RE: Gills Neck Village Center
Developer Response to PLUS review 2015-03-02
Tax Map: 3-35-12.00, Parcel 3.00 (Portion)
DBF No.: 2261J001.F01

On behalf of the Owner / Developer, J.G. Townsend Jr. & Co., we are pleased to submit a revised response to the Office of State Planning's comments for PLUS Review 2015-03-02: The Village Center. On October 9, 2015 we provided a written response to the comments that included a revised schematic site plan that reduces the commercial space (including outparcels) from 235,000 SF to 215,000 SF.

Figure 1 NRCS soil survey mapping update in the immediate vicinity of the proposed construction

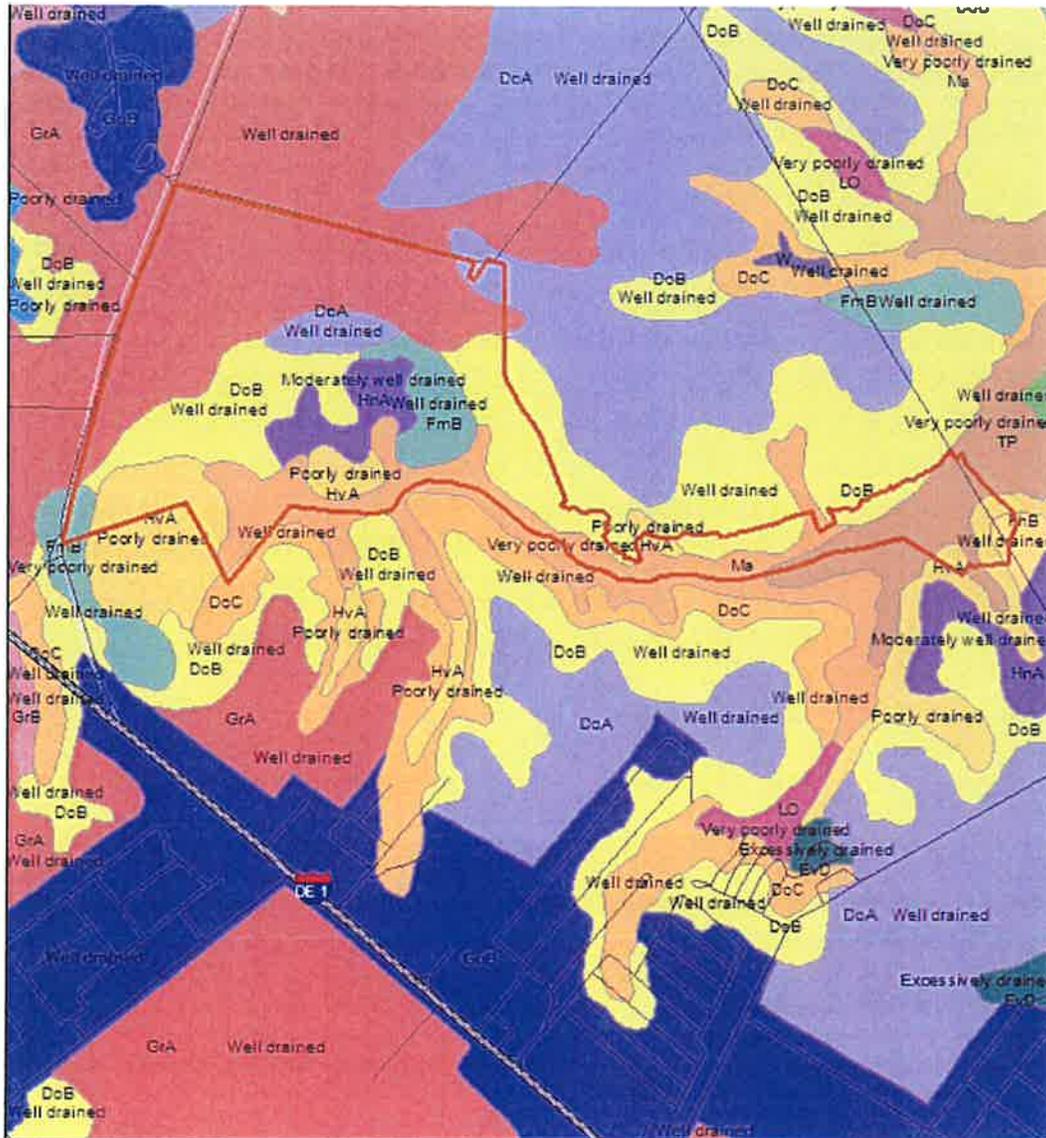
poorly drained wetland associated (hydric) soils that are considered to have severe limitations for development (considered unsuitable). Therefore, DNREC strongly recommends that the applicant avoid development in all hydric soil mapping units. (Figure 1).

Original Response: The soils on the proposed Gills Neck Village Center property are all well drained soils and do not have any limitations on the development of this project.

Revised Response: There is no change from the original response.
